**SIERRA
CLUB**

March 18, 2022

**Re: Puget Sound Energy’s Clean Energy Plan (CEIP) pursuant to WAC 480-100-640
Docket No. UE-210795, Comments of Sierra Club**

Figure 1: E3 chart showing complementary capacity value benefit between solar and storage⁶

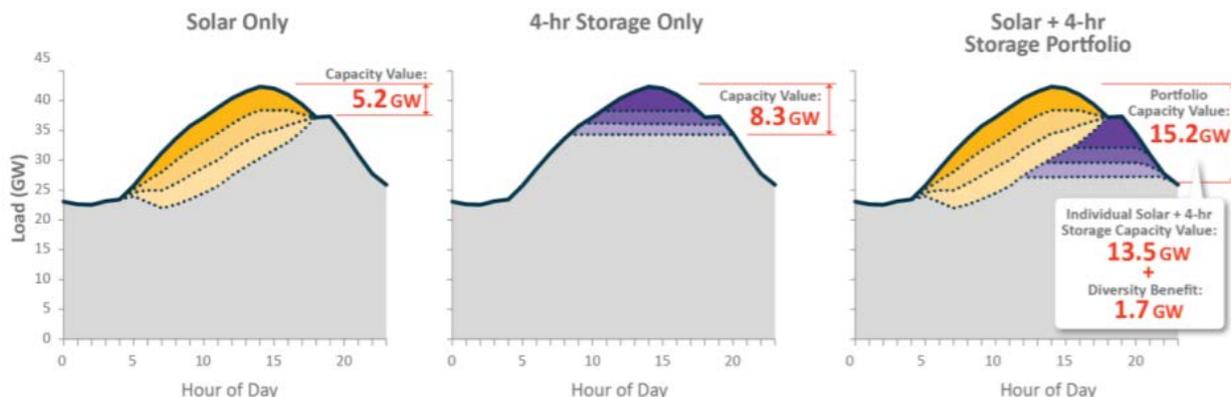
These synergistic benefits among wind, solar, and storage occur because wind and solar have negatively correlated output profiles, and because solar and wind complement storage by shortening the duration of peak net load periods (as illustrated in the example below for a

hypothetical power system). As a result, portfolios of wind, solar, and storage resources provide a capacity value that is greater than the sum of the capacity values of their component parts.

Similarly, geographically diverse wind resources complement each other because their output profiles tend to be weakly correlated. For example, the experts at E3 found that Montana wind resources tend to be most productive during time periods when Pacific Northwest wind output is lower, and vice versa.⁷ As a result, their combined output is greater than the sum of their parts; yet PSE’s analysis did not account for that benefit. Montana wind output also tends to be high during periods when PSE’s demand is high, so E3’s analysis shows that nearly 20 GW of Montana and Wyoming wind can be added to the Pacific Northwest power system before the capacity value of that resource drops below 50% of its nameplate capacity.⁸ As explained above, PSE should directly account for these output profile and capacity value synergies in its modeling of optimal portfolios of resource additions.
